# STORMWATER SITE PLAN REPORT

## STEP BY STEP EARLY LEARNING CENTER

C&A PROJ # 21-003

JULY 9, 2024

# DEVELOPED SITE DRAINAGE BASINS

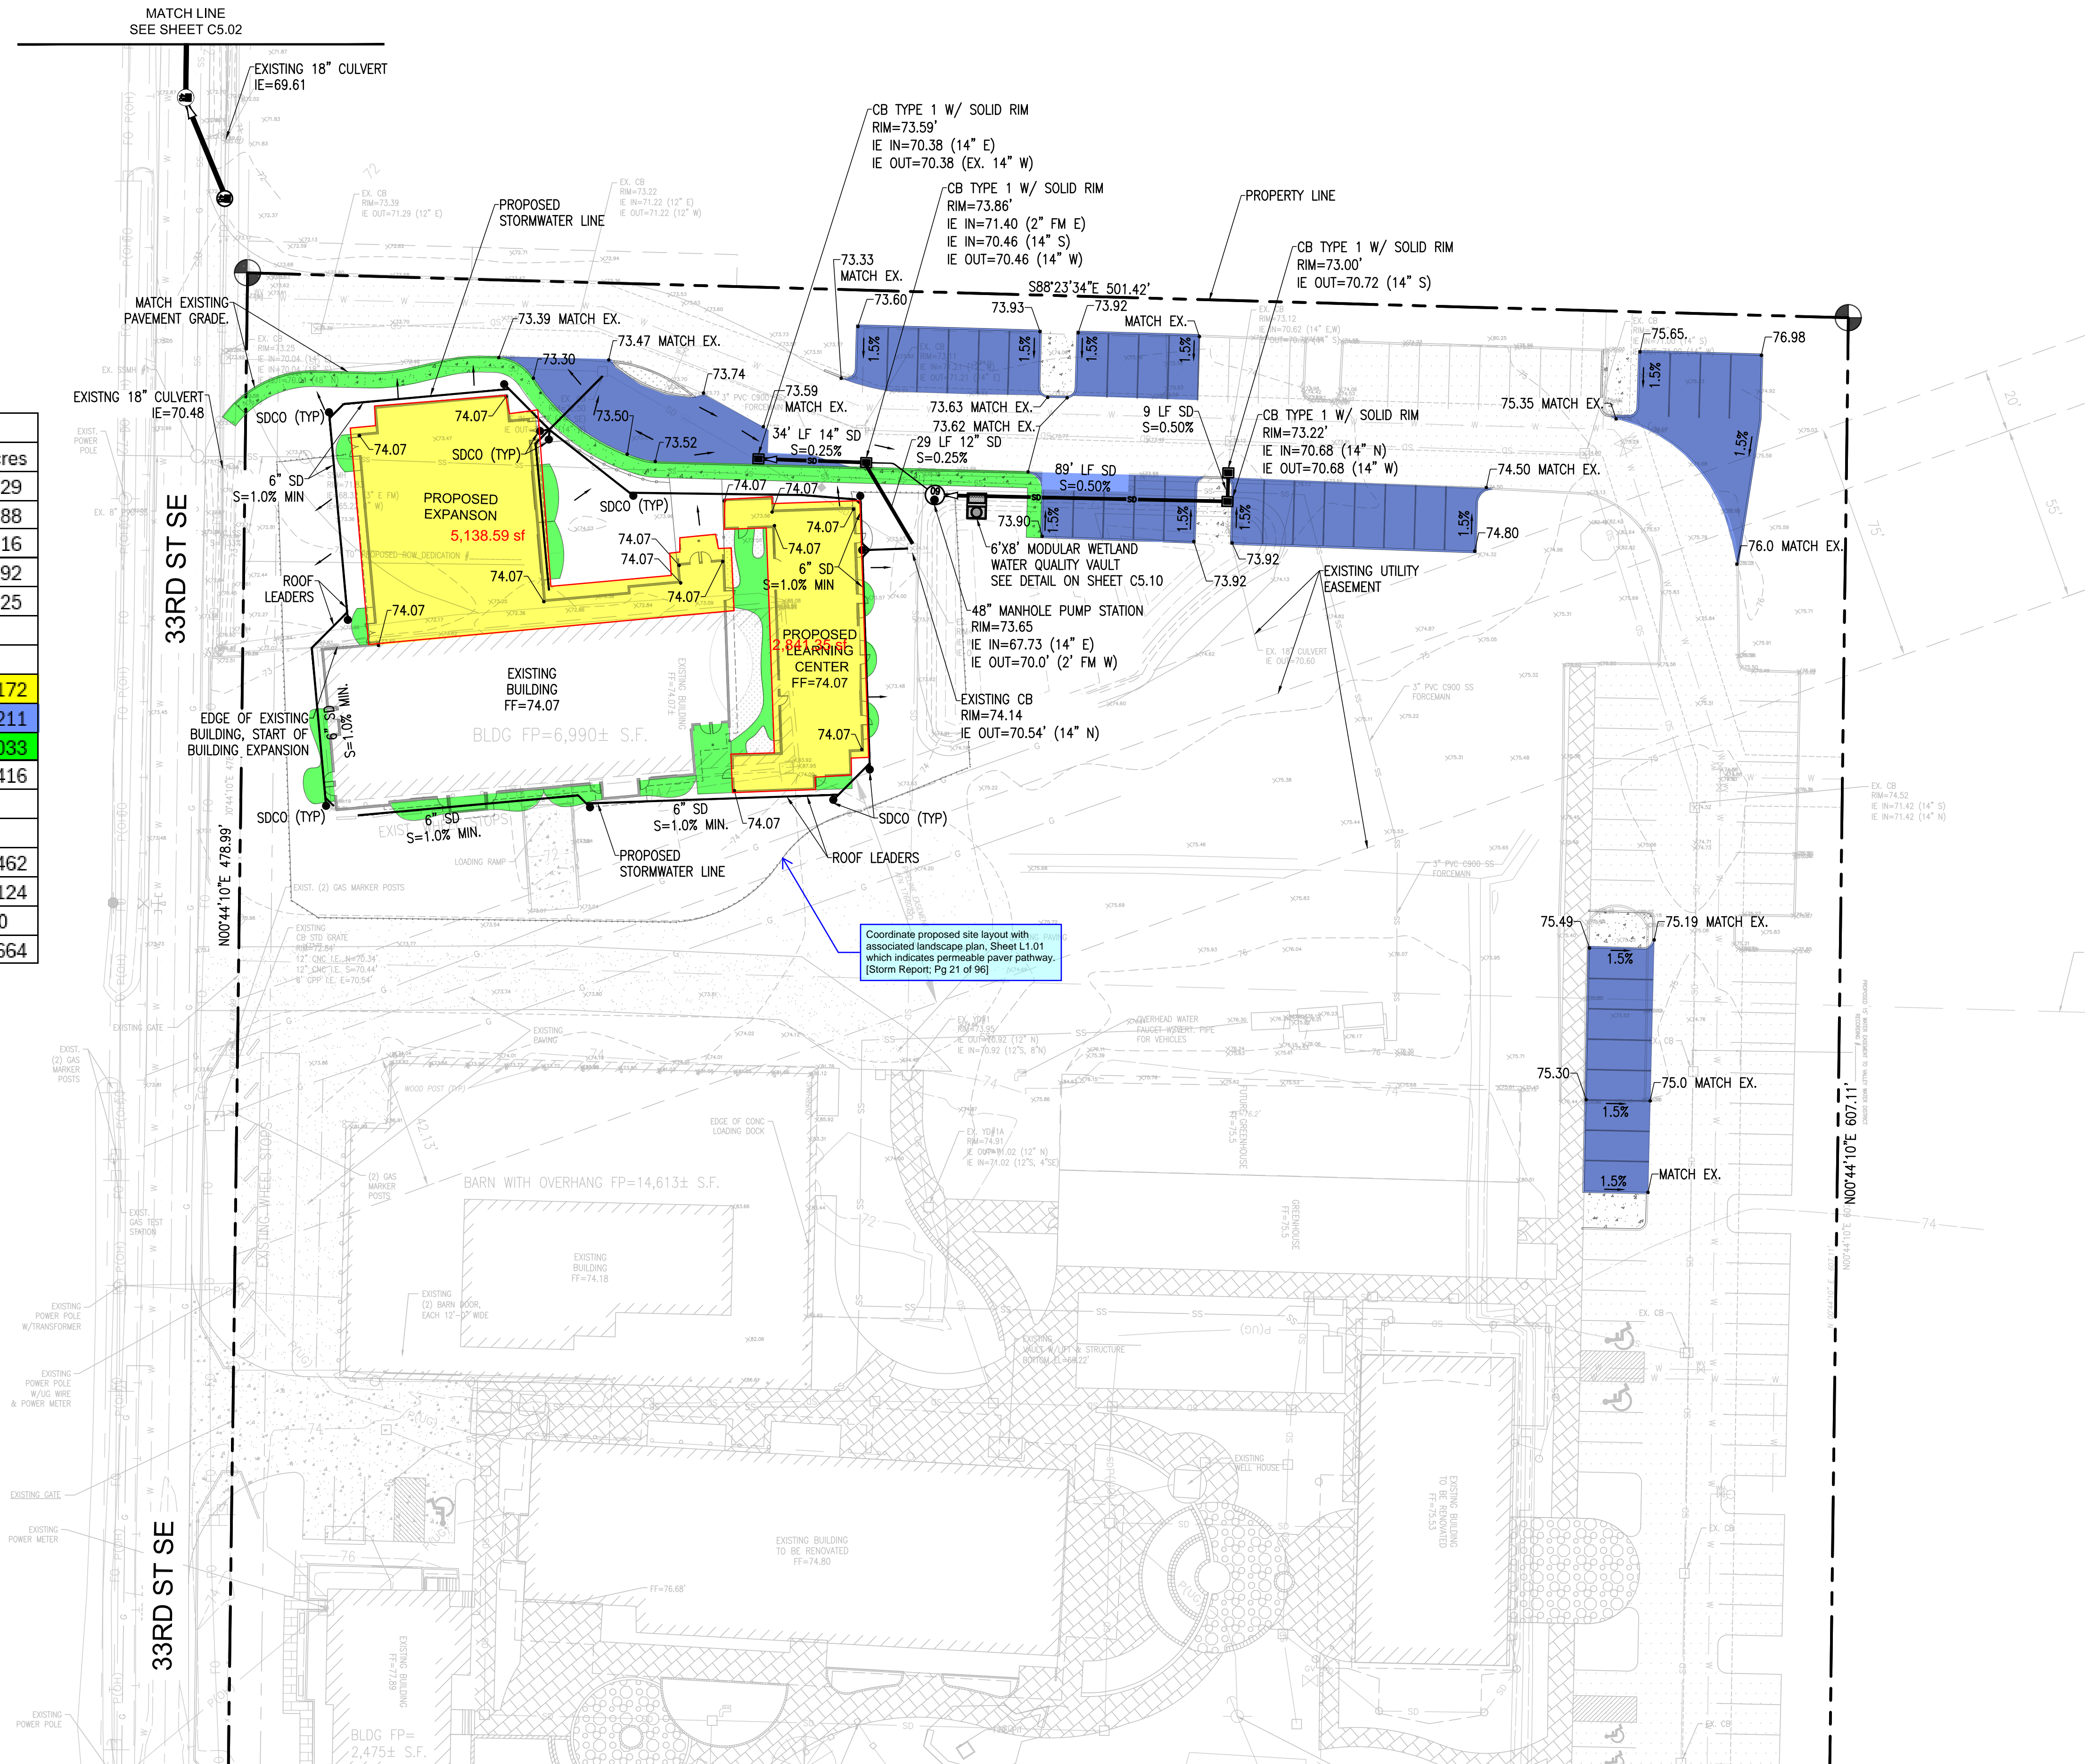
Revise table per comments on the Existing Conditions Map [Storm Report, Pg 22 of 96]
